REAR JCT BOX COVER UPGRADE

On the vehicles affected by this bulletin, to prevent premature corrosion of the rear junction box components, replace the junction box cover with a late model "central mount" cover.

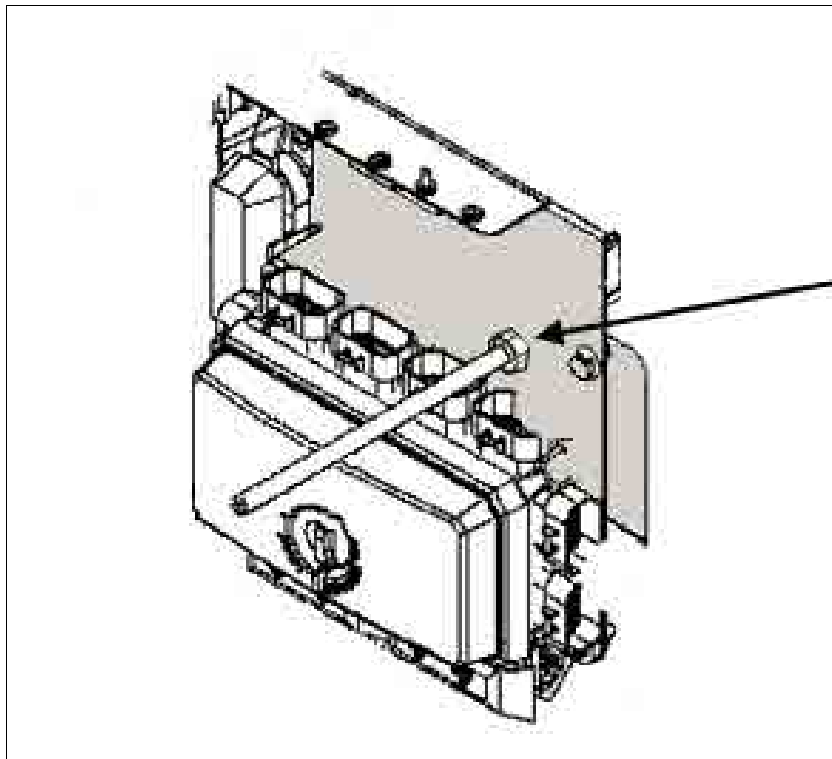
- 2) On the fuse box back plate, drill a 3/8" (10mm) hole following the template and image below (move away wires and harness as required).

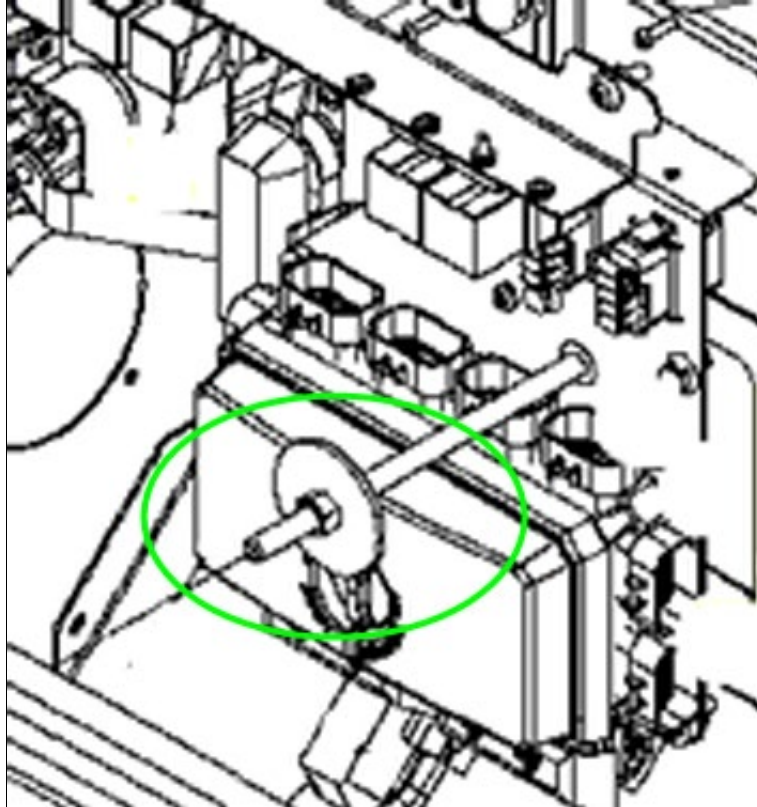
- 3) Insert a 3/8" stainless steel threaded rod of the correct length in the previously drilled hole (rod must stick out of the new central mount cover about 1/2" min), secure the rod to the back plate using two #500102 3/8 SS nuts, one on each side of the plate.

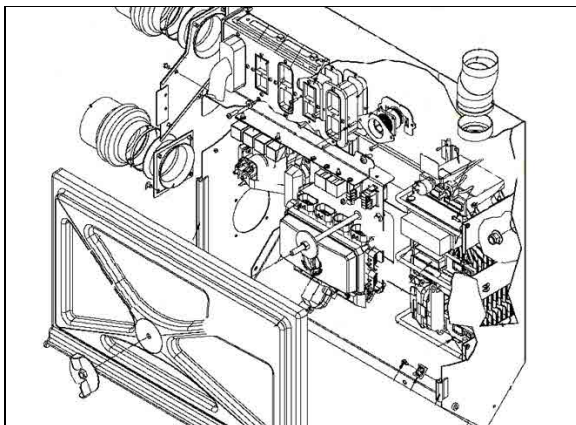
- 4) Install the #068704 washer on the rod (secured with a #500102 3/8 SS nut on both sides) at about one inch below the cover wing nut flange.
